Office Action Summary

10/538,479

DETAILED ACTION

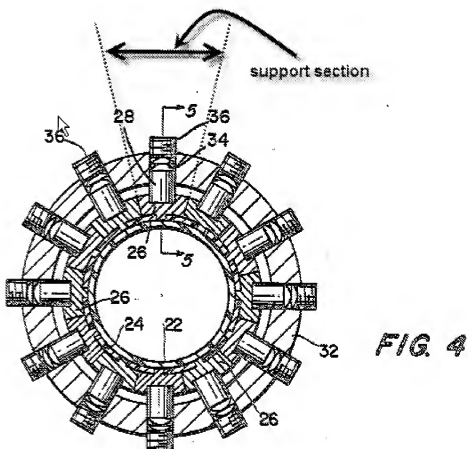
In reference to claim 1, Peritt discloses a gun tube support assembly comprising:

- a plurality of support sections arranged annularly around a gun tube (see marked-up figure 4 below), each including:
 - o a bush housing (figure 4, combination of elements 32 and 36);

- a cradle bush for the bush housing that is capable of receiving and supporting the gun tube (figure 4, combination of elements 26 and 28); and
- a damping means sandwiched between the bush housing and cradle bush that is capable of absorbing and damping kinetic energy emanating from the gun tube during firing thereof (figure 4, element 34).

In reference to claim 12, Peritt discloses that the cradle bush is biased in the direction of the gun tube such that it is capable of keeping the cradle bush in contact with the gun tube and such that it is capable of allowing for thermal expansion of the gun tube (figure 4; and column 3, lines 41-55; and column 4, lines 31-47).

wherein there are two to six support sections arranged annularly around the gun tube (see marked-up figure 4 above), but Peritt does not explicitly state that the support sections are received in an opening in a cradle. Peritt does disclose that said support sections can be welded or mechanically attached to a mounting tripod, pod, aircraft rack, or other stable launching platform (column 3, lines 66-68, to column 4, lines 1-2). Franchino et al teaches that it is known to mount a gun tube support assembly within an opening in a cradle (figures 3 and 4, element 24 and 30; and column 3, lines 40-60) in order to provide rotary elevation adjustment for a gun tube mounted within said gun tube support assembly (column 3, lines 32-34). Thus, it would have been obvious to one having ordinary skill in the art to mount the gun tube support assembly as taught by Peritt within an opening in a cradle in a manner consistent with the teachings of Franchino et al in order to provide rotary elevation adjustment to a gun tube mounted within said gun tube support assembly.
